REPORT ON CHANGES TO LAND USE RESOURCE CONSENT APPLICATION AND CONSENT CONDITIONS

Consent Number: 201.2018.1097/2

Applicant: Kurow Duntroon Irrigation Company

Activity: Changes to application details and conditions of consent for the

Figure 1 – Kurow- Duntroon area with pumphouse locations (source, application for changes Feb 2019)

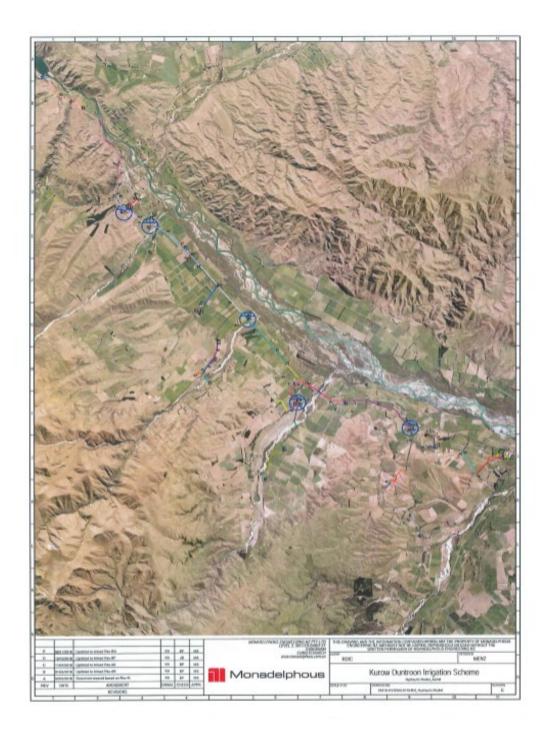
- **a.** Reduction of pumphouses from 7 to 6. This reduction lessens the overall impact of the irrigation scheme, as there will be one less pumphouse that is visible to passers-by.

Pump Shed 2 Location

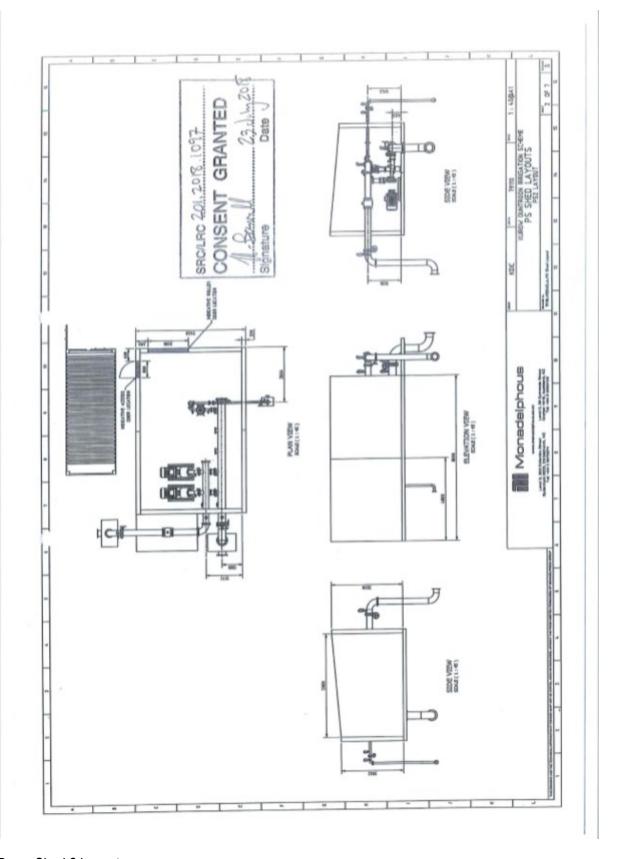
- Pumphouse 2: Set back 4.48 metres. This pump house will be located at the end of a shelterbelt and the applicant advises will have no effect on driver visibility on the road.

Pump Shed 3 Location

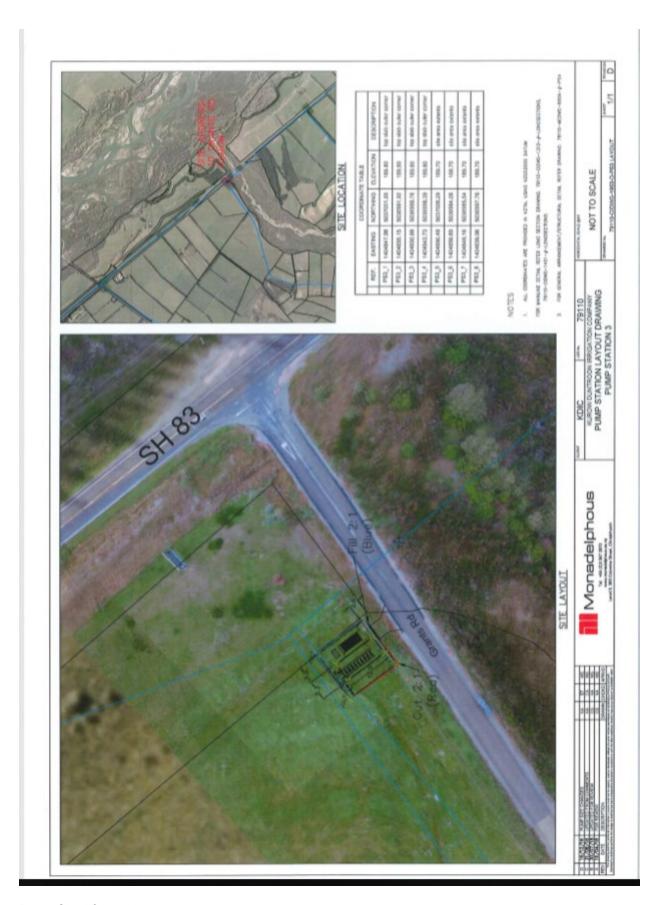
Pumphouse 3: The applicant advises there is no road reserve boundary to measure to. However, the pump shed will be 4.2m from the fence and 9.3m from the sealed surface of Grants Road. The shed is in an open area, some 60m from the intersection of Grants Road and State Highway 80 and will have no effect on driver visibility.

Pump Shed 5 Location

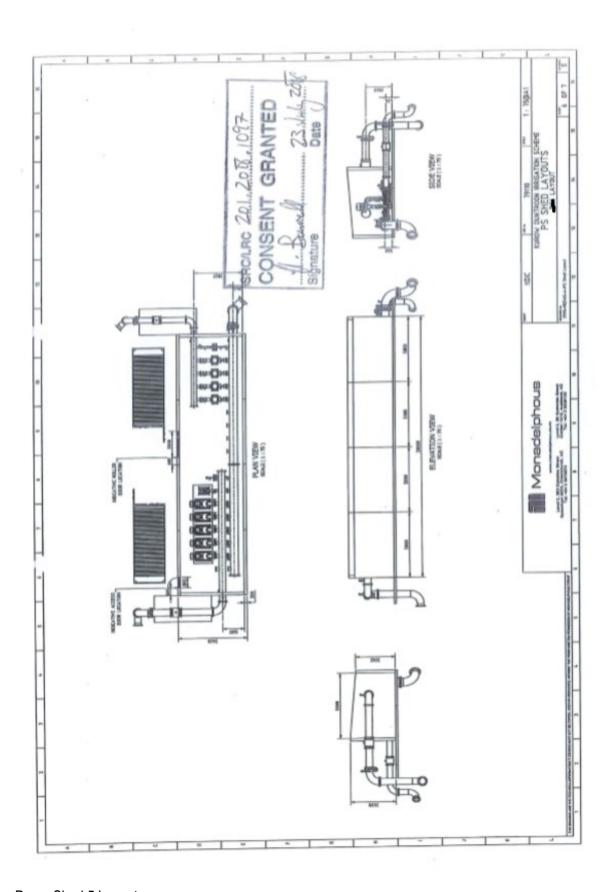
- Pump shed 5: Setback 5.3m. As for pump sheds 2 and 4 the location is adjacent to existing, mature shelterbelt planting and will make no difference to driver visibility.
